U.S. Department
of Transportation

This is in response to your inquiry requesting clarification of the testing requirements for DOT 4E specification cylinders. Your questions are paraphrased below, followed by our answers.

Worthington Cylinder Corporation has some questions concerning 49 CFR 178.68 titled Specification 4E. We are asking the U.S. Department of Transportation for their official interpretation on these issues.

ATTACHMENT A

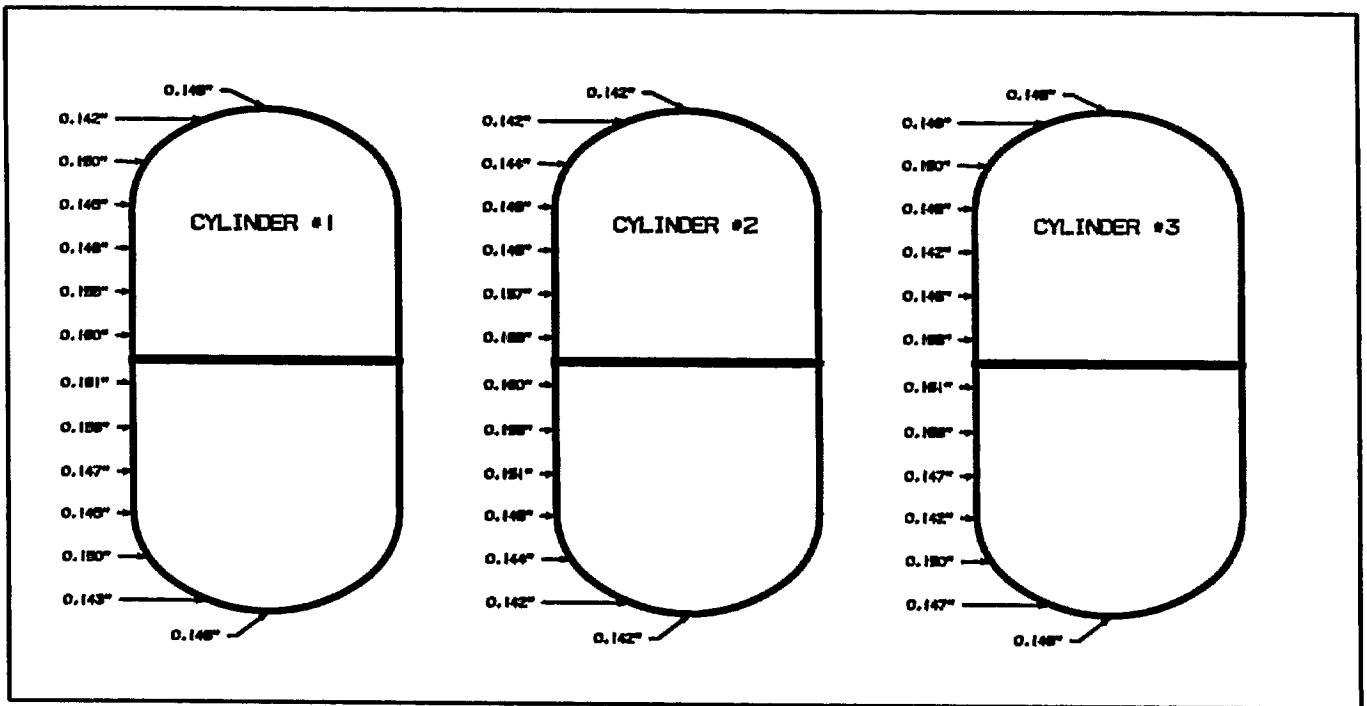
I have enclosed **Attachment A** for your review. This drawing illustrates 3 cylinders manufactured to Specification 4E. The purpose of this drawing is to illustrate the defined minimum wall thickness of the cylinder in accordance with Paragraph 178.68-10. We will assume that the wall stress calculation has indicated the minimum sidewall thickness as 0.142 inches. We will assume that the cylinder sidewall has the tensile strength required of the stress calculation times a factor of two (in this case 35,324 psi).

- It is our interpretation of Paragraph 178.68-10 that all 3 cylinders comply with the requirement. We also interpret Paragraph 178.68-10 to state that in all 3 cylinders illustrated, the minimum wall thickness used for the stress calculation would be 0.142 inches.

Q2: What are the minimum wall thickness requirements of 49 CFR 178.68-10 (now § 178.68(f))?

A2: The absolute minimum wall thickness is 0.140. In addition, the minimum wall thickness must be such that the calculated wall stress at twice the service pressure is less than 20,000 psi or 1/2 the minimum tensile strength, whichever is less. The minimum tensile strength is determined in accordance with § 178.68(j).

ATTACHMENT B

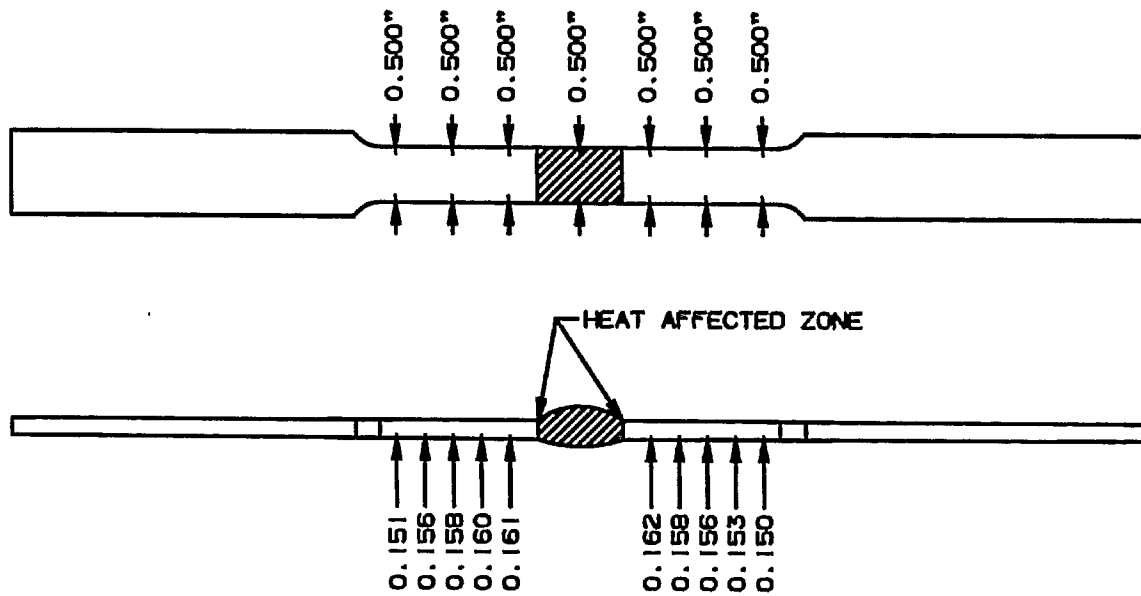
Proper measuring the thickness of tensile coupons has been a question that has been around for a number of years. This is extremely important when testing weld tensile coupons for aluminum cylinders manufactured to Specification 4E for determination of actual tensile strength. I have enclosed **Attachment B** for your review. In reviewing the drawing, I have illustrated a typical tensile coupon for

an aluminum weld. It should be noted that Worthington's experience in testing these welds will indicate that the fracture will occur in the heat affected zone of the weld not in the minimum "thickness" in the reduced area of the tensile coupon.

- It is the interpretation of Worthington, that the minimum thickness noted in the reduced section of the coupon in this illustration would be 0.157 inches. This would then be used as the thickness multiplier in determination of the square inch area of the coupon.. Depending on tensile testing equipment and technique of determining tensile strength, the area would then be used in the equation to determine the actual weld tensile strength as described in Paragraph 178.68-17(a).

Q3: Where should the thickness of tensile coupons be measured?

A3: According to ASTM E8, paragraph 7.1.1: "For referee testing of specimens under 3/16 in. in their least dimension, measure the dimensions where the least cross-sectional area is found".
